Oil Pump Housing Improvement

The oil pump housing may crack.

Inspect the oil pump and replace if applicable.

Inspect the Oil Pressure Adjustment Screw Housing

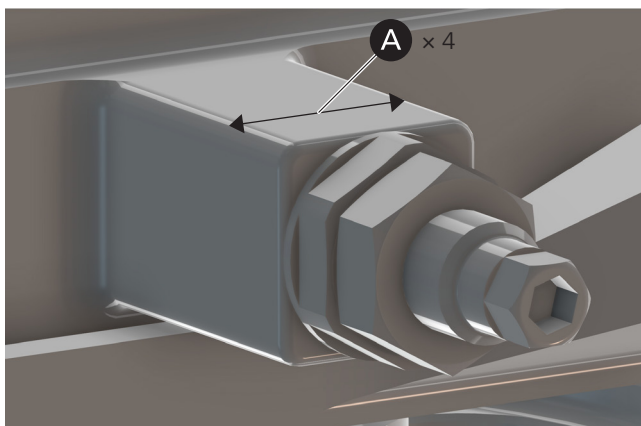
1. Do a check of all four sides **A** of the oil pressure adjustment screw housing. There should be no cracks or oil in the area:

- If you find that there are no cracks and no oil leakage in the area, then no further action is required. Continue to **Install**.
- If you find that there are cracks and/or oil leakage in the area, continue to **Remove** to remove the oil pump and then install a new one.
